Revised Tower Façade Design - North Facade Glare

Response to Glare issues on the hotel North Façade

Revised PPR Scheme

B4N - Hotel - North Elevation, NTS

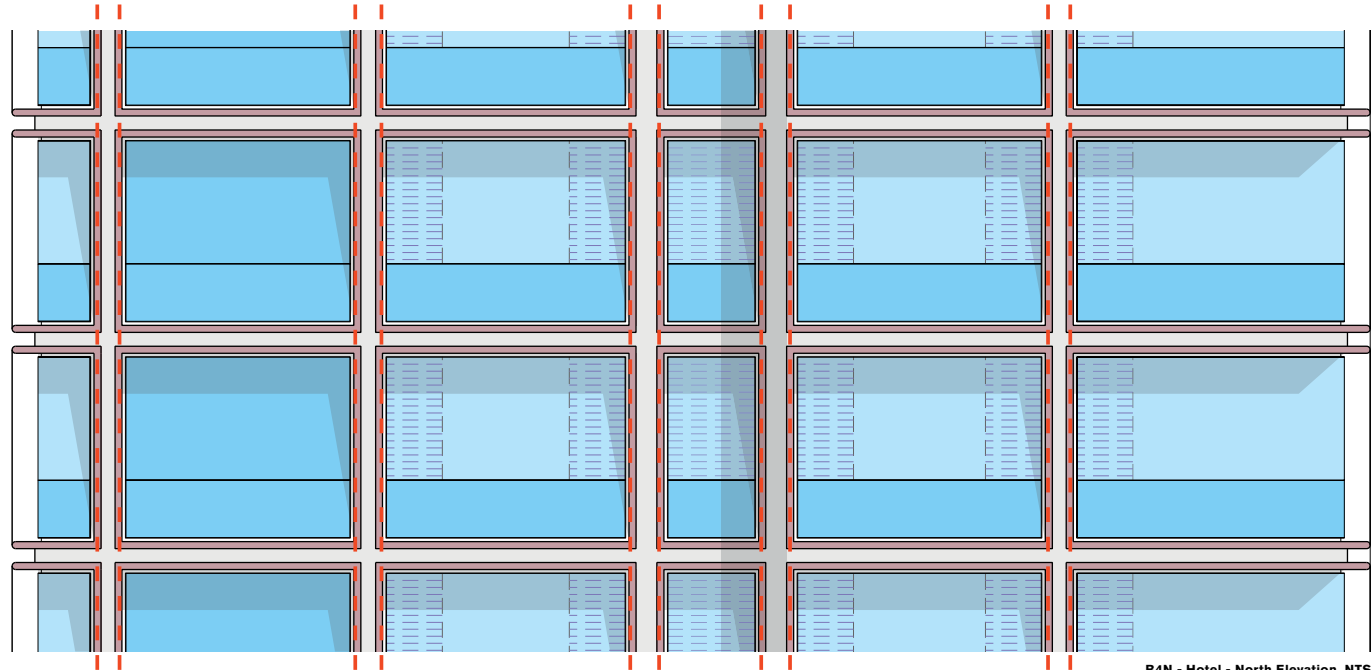
On the northern façade, vertical fin elements to the glazing have been recommended to intercept morning and afternoon solar rays reflecting onto Broadway (see Solar Reflectivity Assessment 4946 for Frasers Broadway, submitted in March 2009 by CPP). Anti glare measures have been incorporated within the cladding module of the hotel itself as each individual unit has been separated from the other by a double vertical fin which protrudes from the outer glazing line.

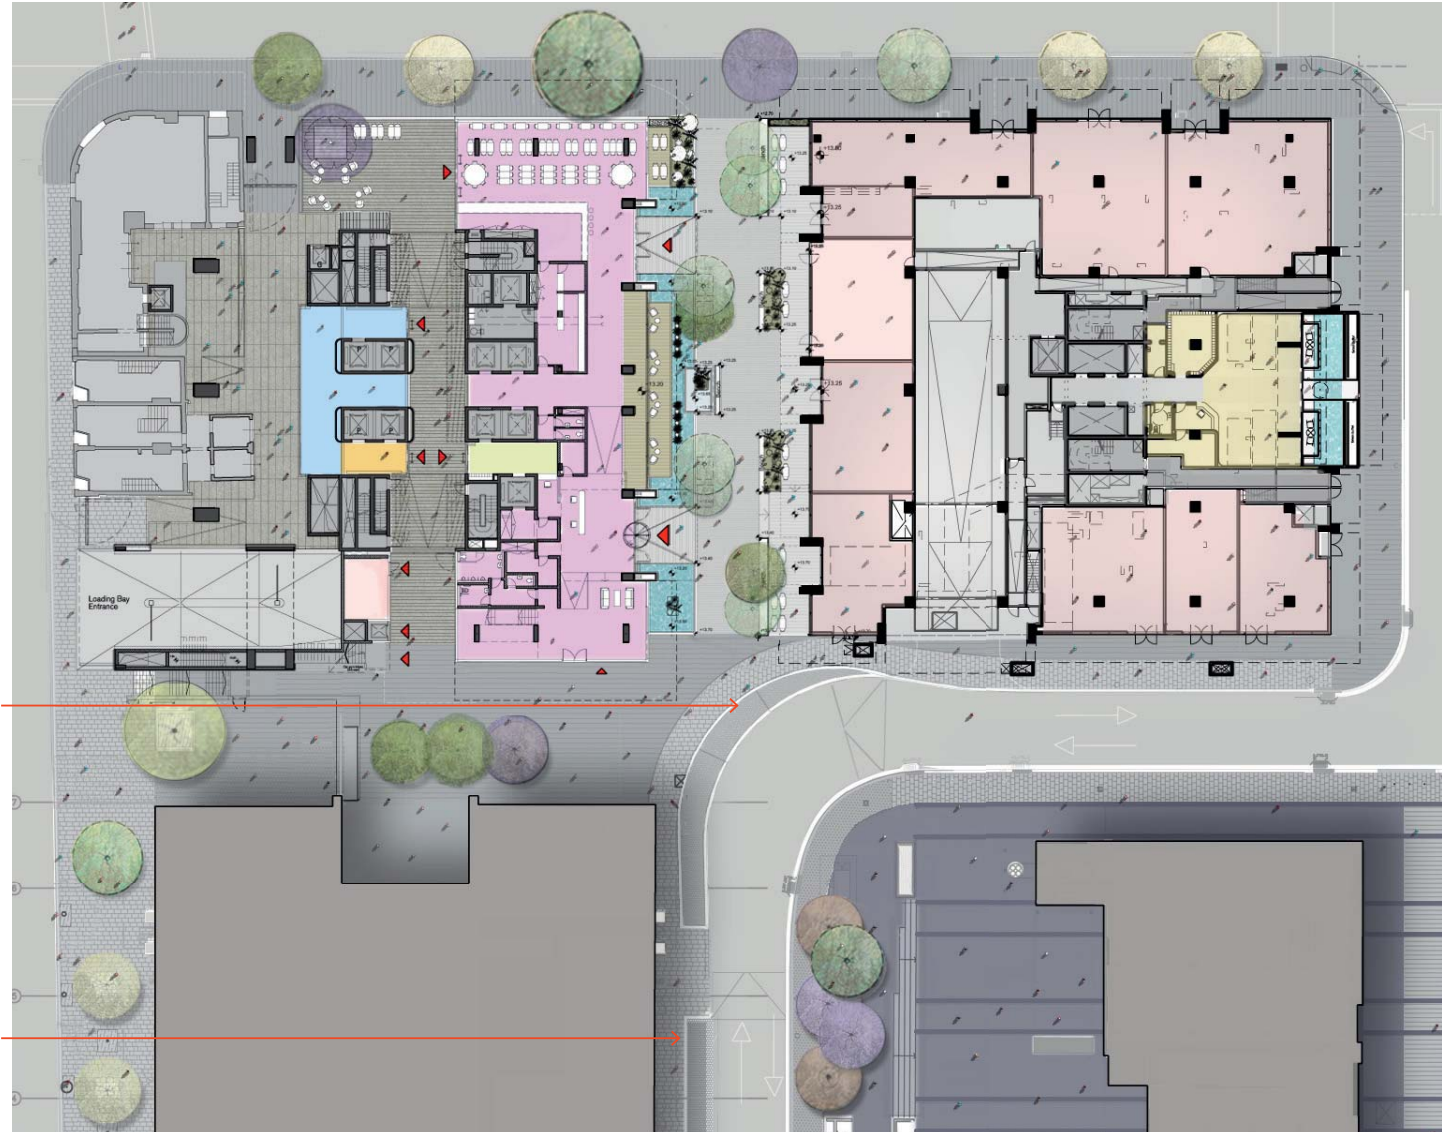
The illustrated plan on this page shows the current landscaping around Block 1 and Block 4N and the design proposal along Central Park Avenue which raised the query relating to the drop-off provision for the hotel and childcare within the DoP&E response letter. The plan also highlights the kink in the transition of the kerb line to the drop-off and parking bays at the corner of Central Park Avenue.

Kink within current landscape design

The revised design along Central Park Avenue addresses the concerns of the drop-off for the hotel and childcare through the introduction of three new parking bays. The new proposal also looks to address the geometry of the Central Park Avenue and the kerb line to ensure a smooth tangential transition from the pavement kerb into the parking bay/drop-off. The landscape design also illustrates the rationalised application of paving materials around both Block 1 and Block 4N. This is explained further in the next chapter within this PPR Summary Report.

- Kerb revised to smooth transition from road to drop-off bays.
- 3no. drop-off bays introduced on to Central Park Avenue.

- Existing 3no. parking bays to be used as additional drop-off bays during the peak morning and afternoon hours.

Revised PPR Scheme

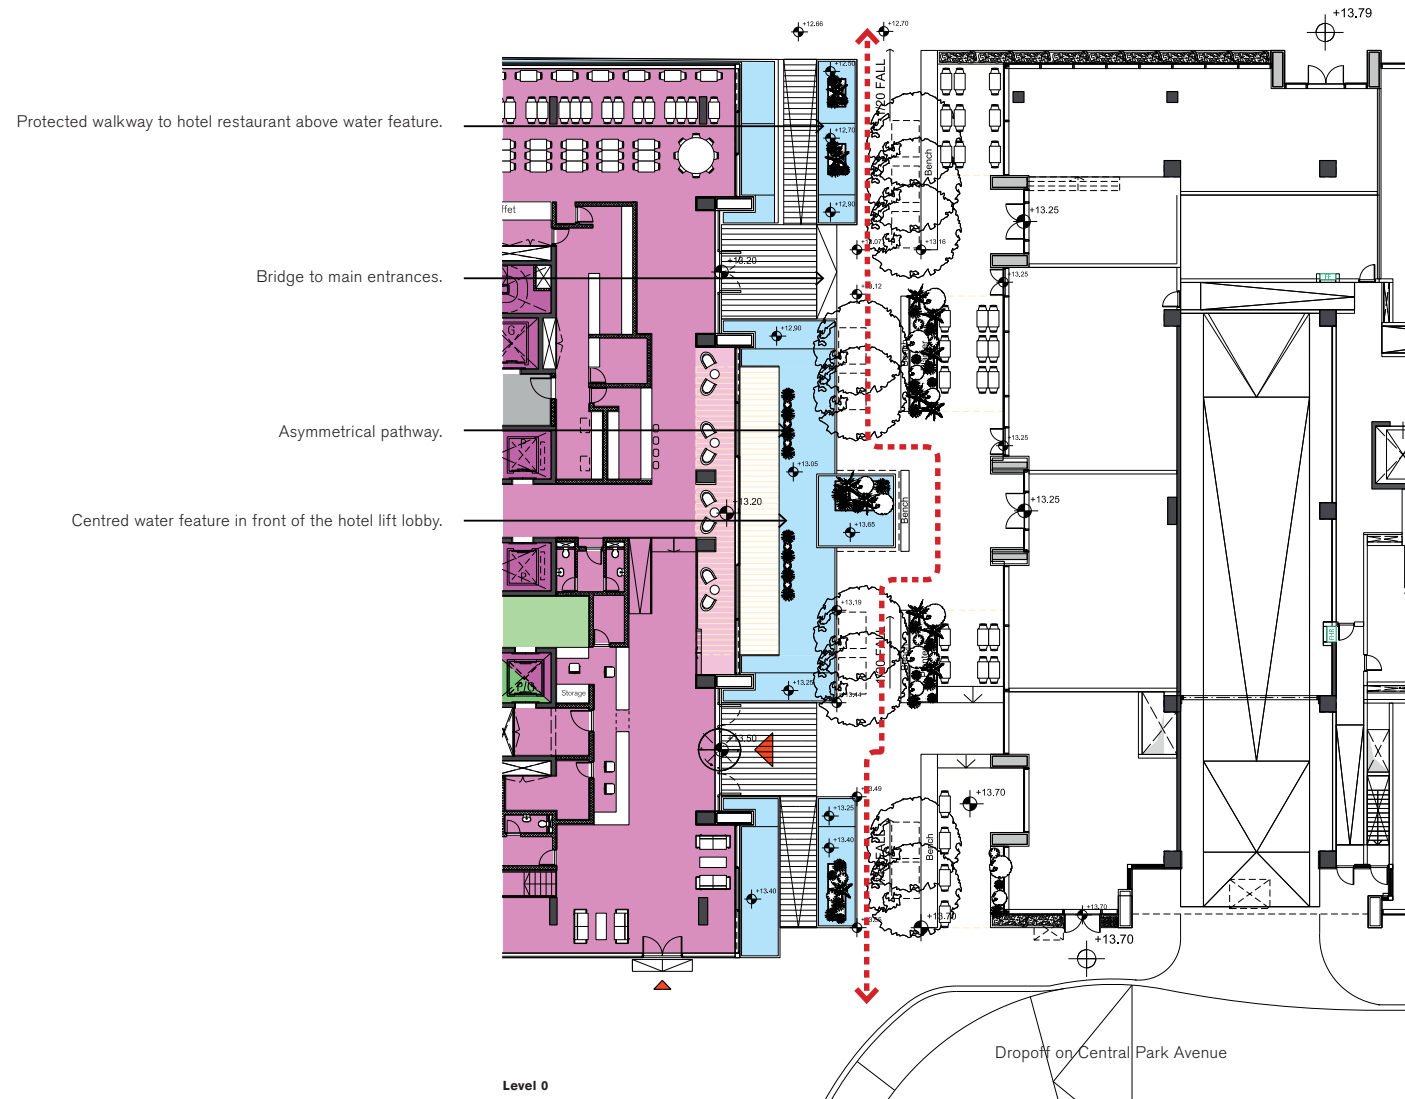
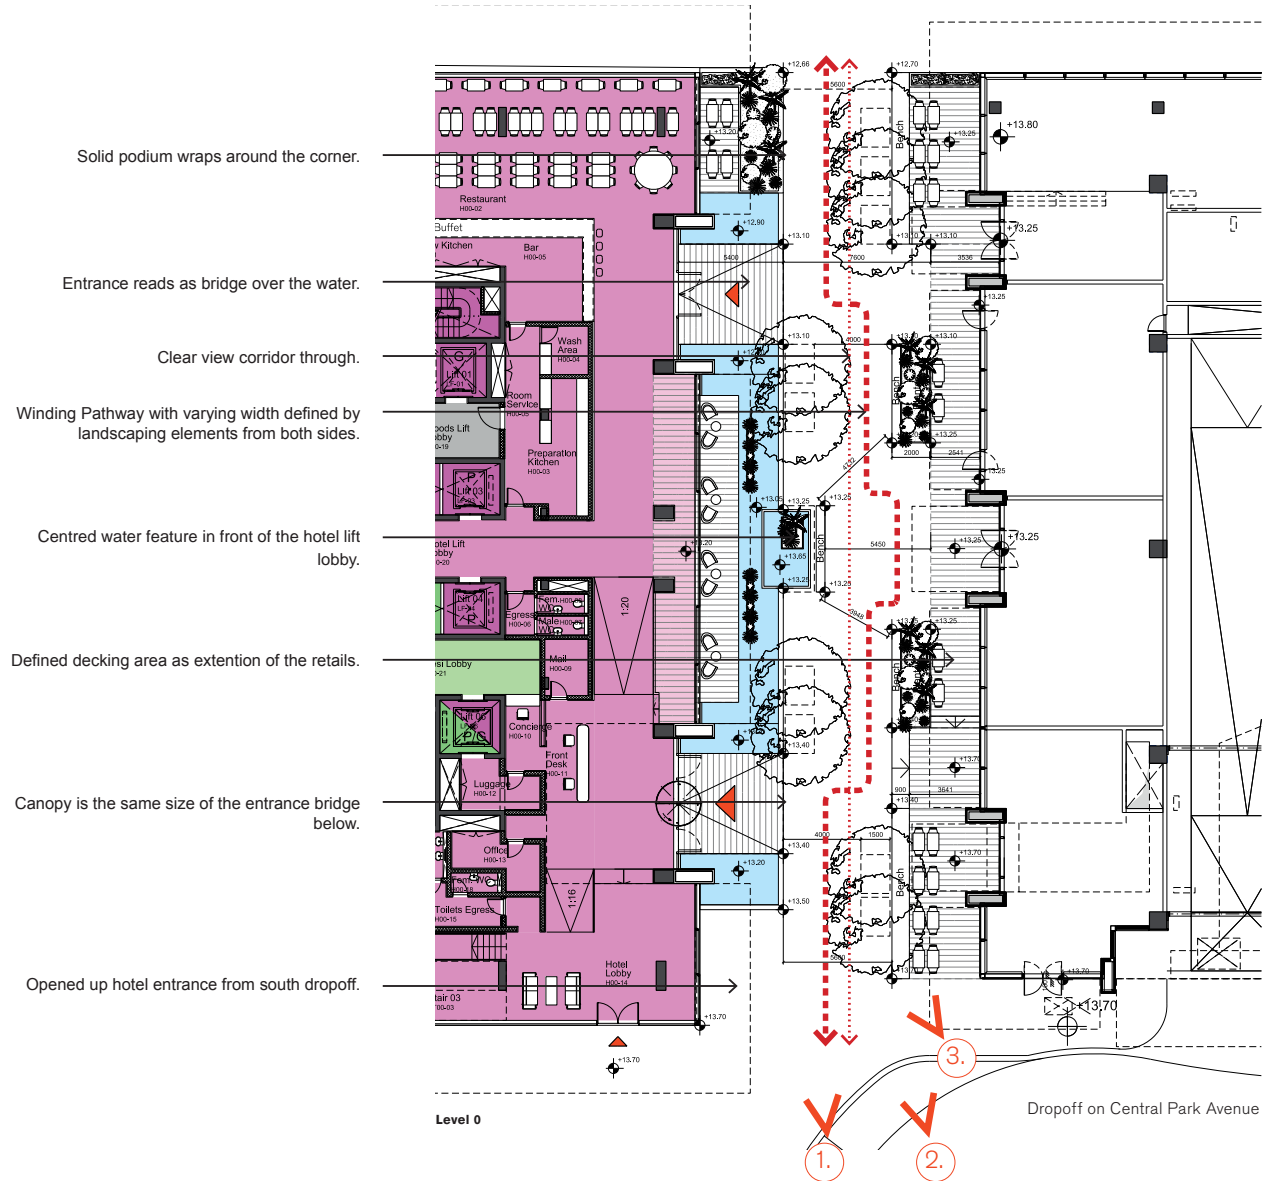
The layout has also been revised within the hotel lobby and reception at the ground floor in the south-east corner to address the change in level between the lobby and the external landscaping in a more satisfactory manner. The previous SSDA proposal proposed an external ramp on the south façade. Upon review, the ramp has been incorporated internally within the hotel lobby to define the reception space at ground level to the conference facility at Level 01 which is accessed from a feature stair to the south of the hotel reception.

Since the SSDA submission, the design of the pedestrian link between Block 1 and Block 4N has been refined to simplify the circulation within the overall space. The design now looks to have access to both the retail within the podium of Block 1 and the hotel restaurant and reception to Block 4N off a central circulation route. This has also allowed for the external terrace or decking areas to the Block 1 podium retail units to be more defined in the design with the areas to be expressed more clearly in the treatment of the surface finish. The revised design has also looked to address the revisions to Central Park Avenue and the clarification of the drop-off design for the hotel and childcare facility and provide a more significant "frontage" to the hotel entrance in the south-east corner.
